Office Action Summary

10/635,249

DETAILED ACTION

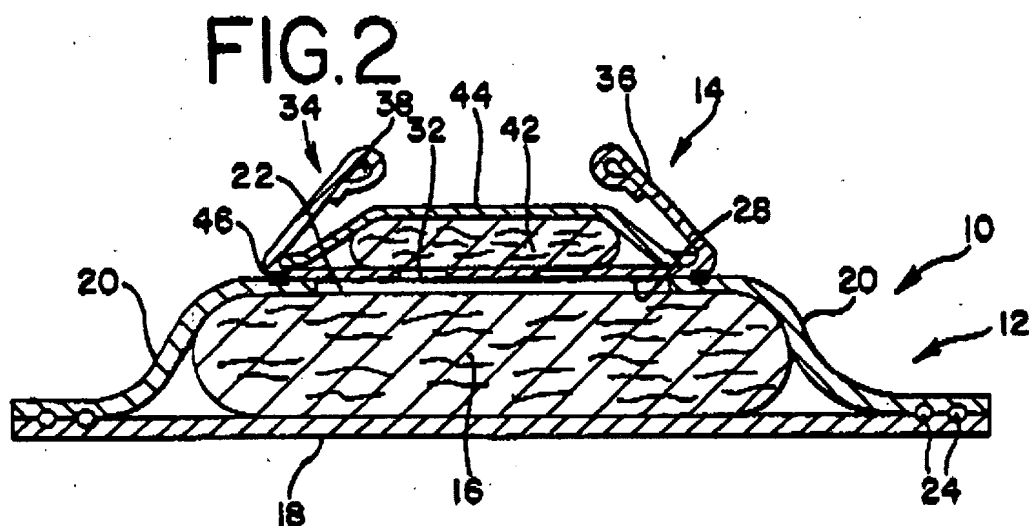
a temperature change element (42, 44) disposed on the topsheet (20) along the longitudinal axis, the temperature change element (42, 44) includes a permeable layer (44) having a body facing surface, a temperature change substance (42) disposed on the permeable layer (44), and an impermeable layer (28) partially wrapped around the permeable layer (44) such that longitudinal edges (36) of the impermeable layer (28) stop short of meeting, leaving a center portion of the body facing surface of the permeable layer (44) exposed (see figure 2, infra).

Regarding claim 20, Zajackowski teaches a temperature change substance (42) disposed between the permeable layer (44) and the leg barrier cuff (28, 36)(see figure 2, supra).

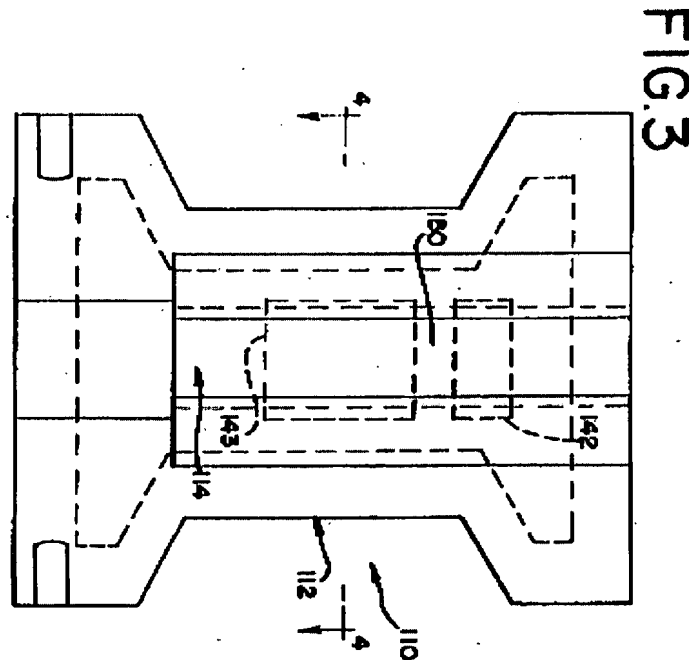
Regarding claim 18, Zajackowski teaches a temperature change substance (42) on a body-faceable surface of the permeable layer (44) in parallel regions (142, 143) covered by the longitudinal edges (36) of the impermeable layer (28)(see figure 3, *infra*).
